## Response to Additional Information Request and Council Submission

This letter has been prepared to respond to the two dot points raised within the Department of Planning's additional information request letter, uploaded to the Major Projects Portal on 6 December 2022 and the City of Ryde submission dated 1 December 2022.

**Figure 1** Stage 1 Mod 5 – C1 Basement 3 Floor Plan, Rev E

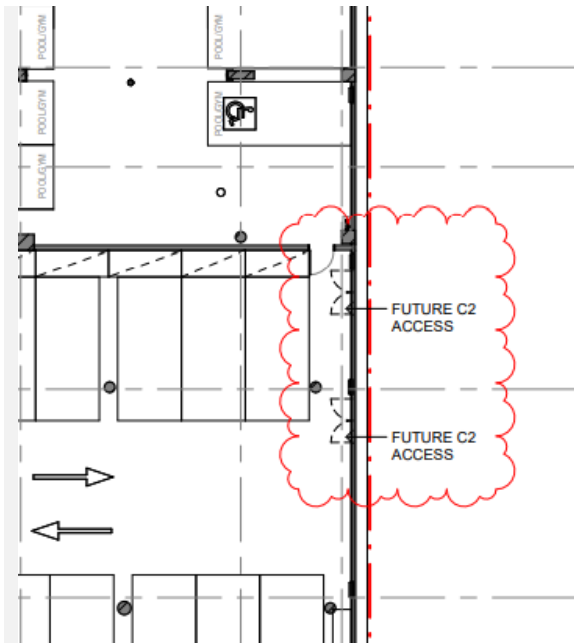
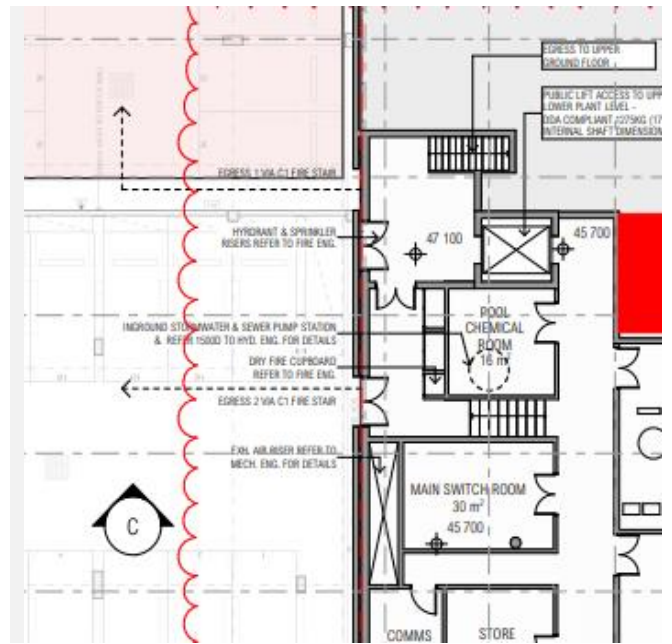
- **Confirm the location of the future access to Building C2, as the one of the proposed access points appear to differ from the Stage 2 Building C2 plans (aligning instead with a Hydrant and Sprinkler riser).**

Figures 1 and 2 below provide a comparison of the future access between Buildings C1 and C2 and demonstrates that the future access points align. We confirm that a previous version of the Stage 2 plans would have resulted in the alignment of the entry with a hydrant and sprinkler riser, however a comparison of the most recent set of plans relating to Stage 2, and those before the Department of Planning currently, demonstrates that the openings align with the plan set provided as part of the subject modification request.

**Figure 3** Extract from C1 Construction Drawings, showing the construction detailing of the fire control, pump room and plant room.

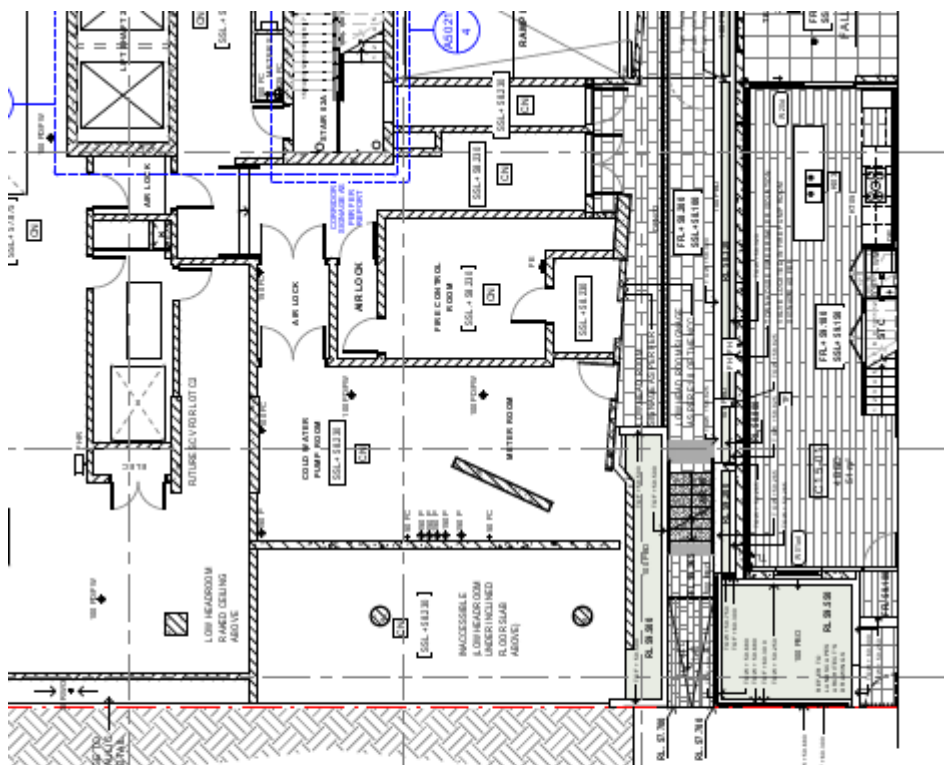
- **Provide additional details into the reconfiguration of the fire control room, cold water pump room and plant room, including whether landscaping along the street frontage would be impacted.**

An extract from the Construction Drawings is provided at Figure 3 below, providing additional detail of the configuration of the plant rooms near the entry to Building C1.2.

**Figure 11 Stage 2 Plans – C2 Lower Ground Floor Plan, Rev 11**

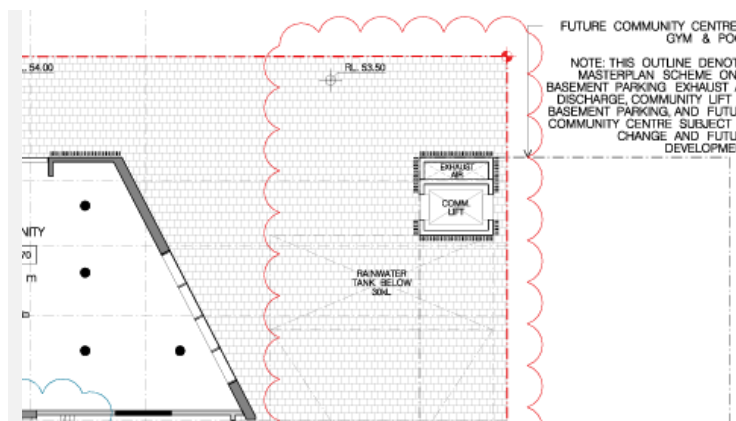
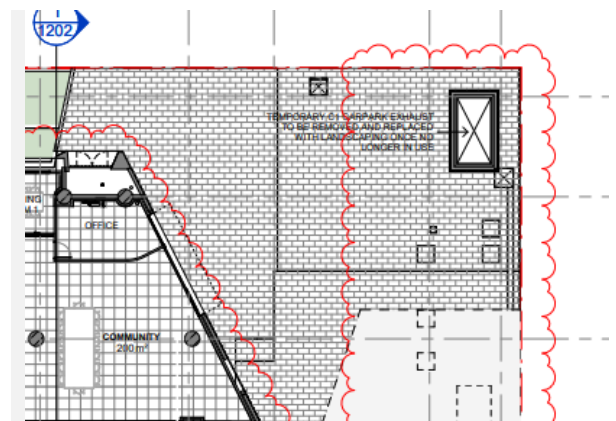
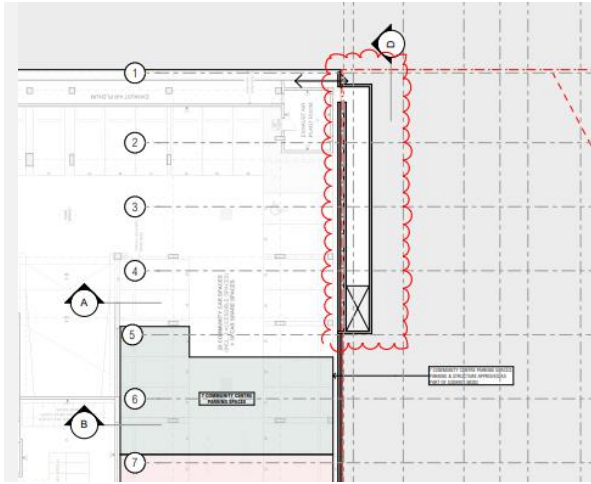
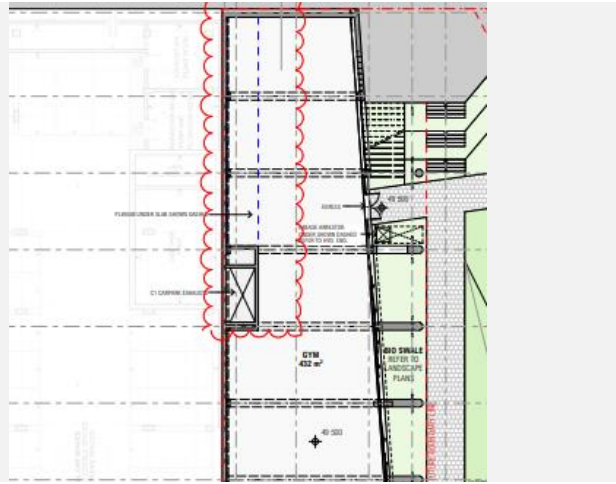
- Basement 1 plans show proposed amendment in regards to the Exhaust Air Discharge which affects the Waste Loading Dock. Please ensure that this will not impede on the height clearance of the truck and that there will be no exhaust fumes occurring in the loading dock area. A min 4.5m head clearance would be required.**

The Waste Loading Dock area is not affected by the relocation of the Exhaust Air Discharge. The relocated Exhaust only relates to the carpark area which is not attached to the Waste Loading Dock. The Waste Loading Dock has a separate exhaust system to that of the carpark and as a result of this modification there is no change proposed to the Waste Loading Dock or it's exhaust system. There will be no change to the height of the loading dock which will maintain a min. 4.5m head clearance as required.

The proposed amendments to the exhaust air discharge relate to the relocation of Building C1 carpark exhaust locations into Building C2, with a temporary location nominated in the eastern corner of the site which is annotated as to be removed and replaced with landscaping once no longer in use, i.e. when Building C2 is completed and the new exhaust location is constructed within the built form. Figures 8, 9 and 10 below show the approved location of the C1 car park exhaust, the proposed amendments sought as part of the subject modification and the Stage 2 plans currently before the Department. Figure 11 demonstrates the location of the exhaust within the C2 building on the proposed Low Ground Floor Plan.

We confirm that the modifications sought do not result in any change to the exhaust air discharge affecting the loading dock, exhaust fume discharges or changes to the height clearances.
